**Development Application
Assessment Report D/2017/524 -
44 Martin Place, Sydney**

DEVELOPMENT APPLICATION ASSESSMENT

Application No:	D/2017/524
Date of Lodgement	28 April 2017
Applicant	GWYNVILL PROPERTIES PTY LIMITED
Architect	HASELL
Developer	GWYNVILL PROPERTIES PTY LIMITED
Application Site:	44 MARTIN PLACE, SYDNEY NSW 2000
Proposal:	Construction of a two storey addition at roof level accommodating two commercial floor levels; creation of a central atrium from lobby to roof level; internal alterations at basement level; BCA, fire safety and access upgrade of building; and installation of facade lighting. No changes are proposed to existing retail tenancies to Martin Place, Castlereagh Street and Hosking Place. The proposal is Integrated Development under the Heritage Act 1977, requiring approval by the NSW Heritage Office.

Figure 12: Roof level floor plan depicting approximate location of setback requested by the Heritage Council.

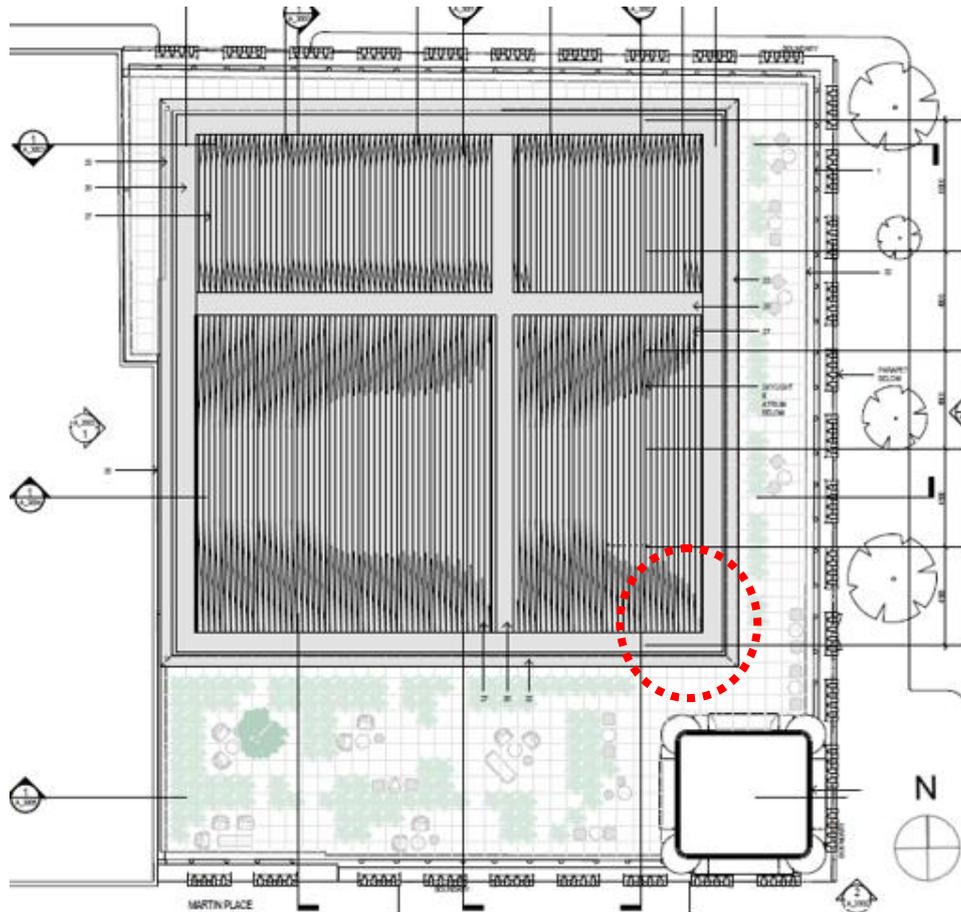
At the request of the applicant, the setback condition was reconsidered by the Heritage Council of NSW at its meeting on 4 July 2018. On 12 July 2018, the Heritage Council of NSW resolved to amend the General Terms of Approval to delete the setback condition, and replace it with a requirement for the south-east corner of levels 11 and 12 to be further setback to maximise the view of the tower in the round. The location of the setback is detailed in the floor plan below:

It is noted that the setback requirement is not quantified by the Heritage Council in the General Terms of Approval, however will become a condition of consent.

Additionally, the following design modifications and details to be submitted with the Section 60 application:

- The colour of the finishes of the facades of Levels 11 and 12 are to be recessive to distinguish them from the masonry facades of the heritage building.
- The extant openings in the eastern lobby wall of the ground floor foyer are to be retained. The removal of columns is not approved. This is in line with the CMP (policy G4) which identifies the openings as significant.
- The nib wall to the west of the entry (at ground floor) is to be retained as it is original wall fabric.
- The proposed ground floor lobby flooring is not approved and a closer interpretation of the original floor is required.

- A schedule of conservation works in accordance with the CMP policy J is to be prepared.
- Details of the design of the proposed rooftop balustrade is to be submitted.
- Information on the significance of the Hosking Place granite fabric is required before modifications can be made to accommodate a new fire booster and exit doors.
- Information about the proposed external lighting of the facade at night is to be submitted.
- Any moveable heritage is to be reinstated, particularly any boardroom furniture held in offsite storage.
- Upgrade of services are to be planned and implemented with input by the nominated heritage consultant.

Figure 13: Perspective of the proposed development showing LEP height non-compliance above the red height plane

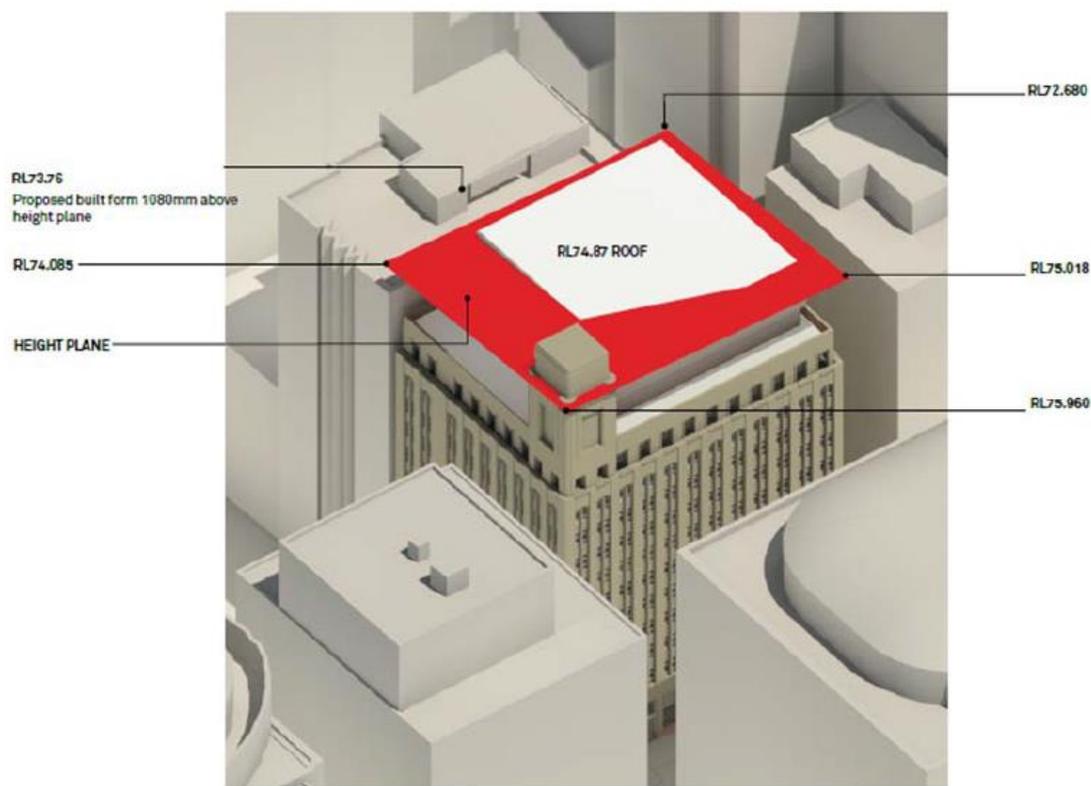
The application proposes a minor non-compliance with the Sydney LEP 2012 in relation to the maximum height in metres. The proposed addition will have a height of 57.1m at its highest point, where 55 metres is permitted under Clause 4.3. This results in a variation of 2.1 metres, or 3.8%. The existing turret on the site is already non-compliant with the LEP height at 59.12 metres as demonstrated below:

The applicant has lodged a written request under Clause 4.6 of the LEP seeking to justify the contravention of the height standard of 55m. The applicant contends the following when stating their case that compliance with the standard is unreasonable

It is considered that in this instance, strict compliance with the height of buildings development standard specified by Clause 4.3 of the LEP is unreasonable and unnecessary pursuant to Clause 4.6(4)(a)(ii). There are sufficient reasons to justify exceeding the development standard as follows:

It is considered that the written statement provided by the applicant has sufficiently justified that strict numeric compliance with the development standard is unreasonable and unnecessary in this instance. For the reasons outlined above, there are sufficient planning grounds to justify the departure from the height of buildings development standard and it is recommended that a Clause 4.6 exemption be granted, pursuant to the Director-General's general concurrence of May 2008.

Figure 16: Section through the development depicting the Castlereagh Street setback

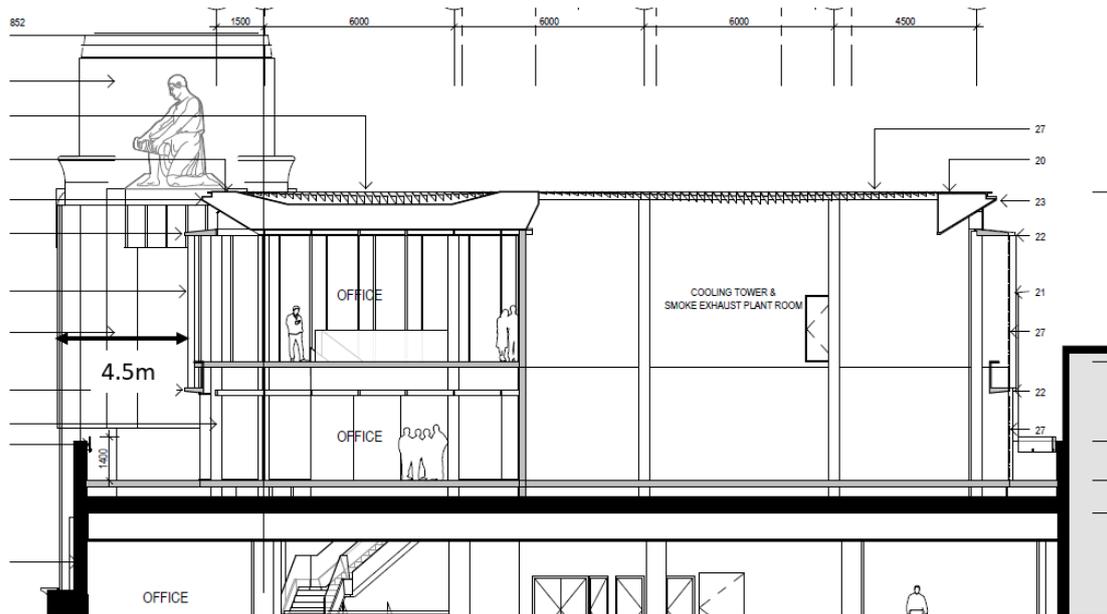
Section 5.1.2.1(3) of the Sydney DCP 2012 requires additions above a heritage item to be setback at least 10 metres. Section 5.1.3(1) of the Sydney DCP 2012 however,

The predominant height control for the site is set by the sun access plane to Martin Place, which the proposal complies with, as detailed elsewhere in this report. The DCP control specifying that no additional height is permitted above the existing street wall height is therefore inconsistent with the LEP control.

The subject site currently contains rooftop structures in the form of plant rooms, lift overruns and cooling towers at an overall height of 50.84 metres (when measured from Martin Place), which contravenes the Martin Place Special Character Area provisions. It is also noted that D/2011/733 for 50 Martin Place, Sydney (directly opposite the site) was granted consent for a rooftop addition with a setback of 4 metres to Castlereagh Street, and approximately 8 metres to Martin Place. This consent does not comply with either the front setback controls or the Martin Place Special Character Area requirements.

The proposed variation to the front setback requirements meets the objectives contained in Section 5.1.2, and the setbacks for Special Character Areas contained in Section 5.1.3 of the Sydney DCP 2012, and is acceptable in this instance for the following reasons:

- Setting back the addition 10 metres from all frontages to achieve technical compliance with the general front setback control would not create any beneficial streetscape, perceived scale or amenity impacts for the public domain.

The rooftop structure has been designed as a low scale, lightweight addition and is placed behind the existing tower and parapet.

Figure 17: Map of view analysis points (A – Castlereagh Street south, B – Martin Place East and 16 – Castlereagh Street north)

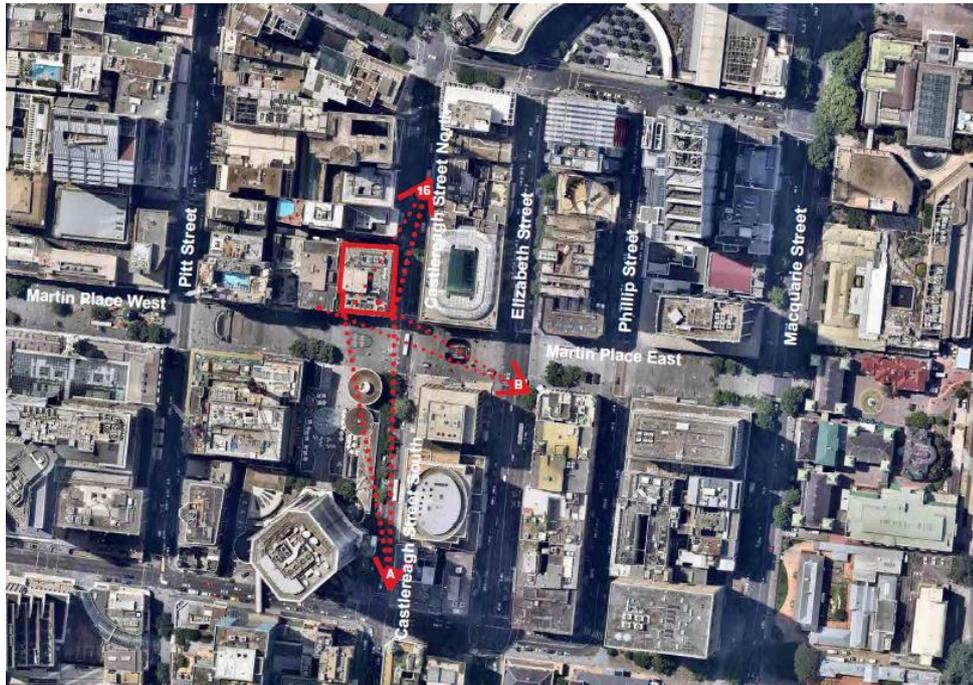
Setting back the addition by 10 metres to Martin Place, 4.5 metres to Castlereagh Street and 2.5 metres to Hosking Place as proposed results in the addition only being visible from along certain points within Martin Place

and Castlereagh Street. The applicant has prepared a view analysis of the proposed development, demonstrating that the addition can be partially viewed within the following locations:

As demonstrated in the images above, the addition is only partially visible from surrounding streets as an inconspicuous, lightweight structure against the backdrop of much larger buildings. The addition is visually submissive to the existing heritage building when viewed from the public domain, and complements the architecture of the base building. The proposal will not be

visible from close quarters where complete iconic views of the primary south (Martin Place) facade of the heritage building are possible.
